SECTION 00 9113.2 - ADDENDUM 2

- A. Project Name: **Wee Links Pro Shop Shelter Addition.**
- B. Owner: **Minot Park District**
- C. Architect: **Ackerman-Estvold, Engineering & Management Consulting, Inc.**
- D. Architect Project Number: **R25104.01.**
- E. Date of Addendum: **3/6/26.**

ADDENDUM # E-1

Wee Links Pro Shop Shelter Addition
Minot Park District
Minot, North Dakota
Project Number: 25058

3 ROOF PLAN
A100 SCALE: 1/8" = 1'-0"

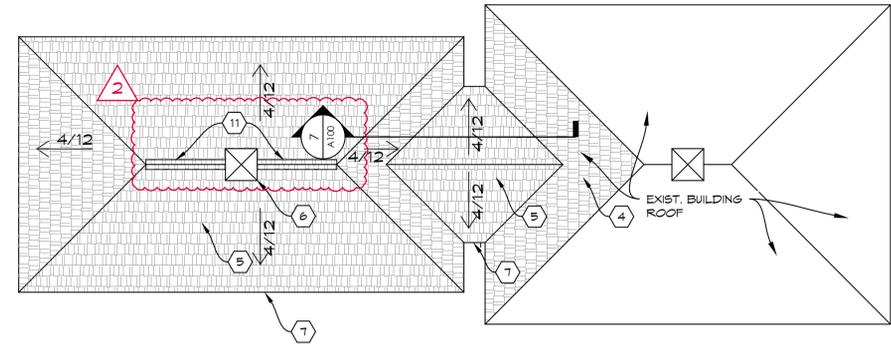
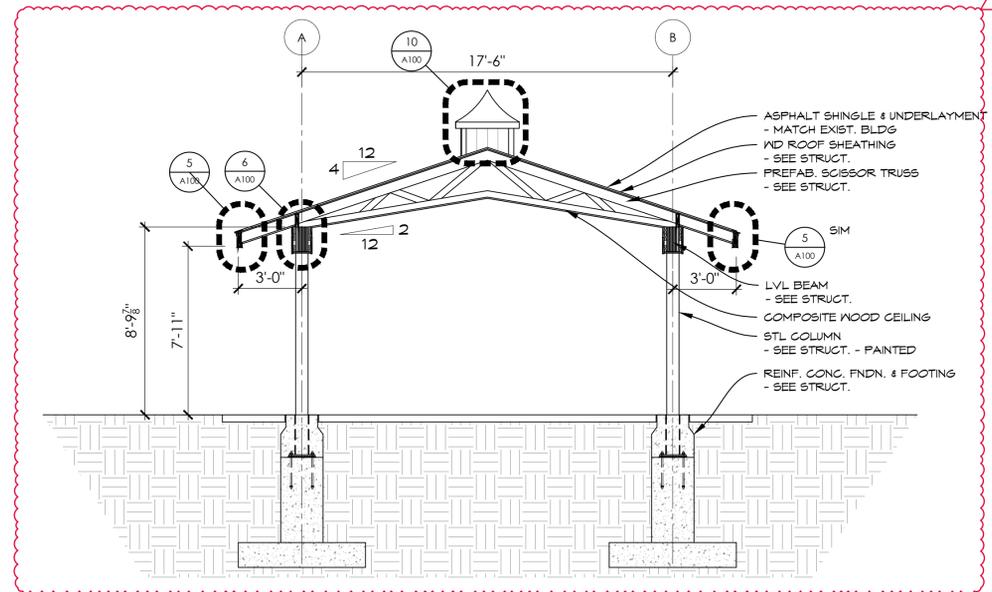
- A. Added Soffit and Ridge vents on details for ventilation.

- 1 LVL BEAM - SEE STRUCTURAL
- 2 COMPOSITE WOOD CEILING & SOFFIT
- 3 STEEL COLUMNS - SEE STRUCTURAL - PAINTED
- 4 RE-SHINGLE THIS SURFACE OF EXIST. ROOF FOR CONNECTING LINK TIE-IN
- 5 ARCHITECTURAL ASPHALT SHINGLE SYSTEM - MATCH EXISTING COLOR
- 6 CUPOLA - SEE DETAIL 10/A100
- 7 EAVE - SEE DETAIL 5/A100
- 8 NEW CONCRETE SLAB - SEE CIVIL
- 9 NEW CONCRETE PLATFORM - SEE CIVIL
- 10 CONTINUOUS SOFFIT VENT. SEE SPEC.
- 11 RIDGE VENT
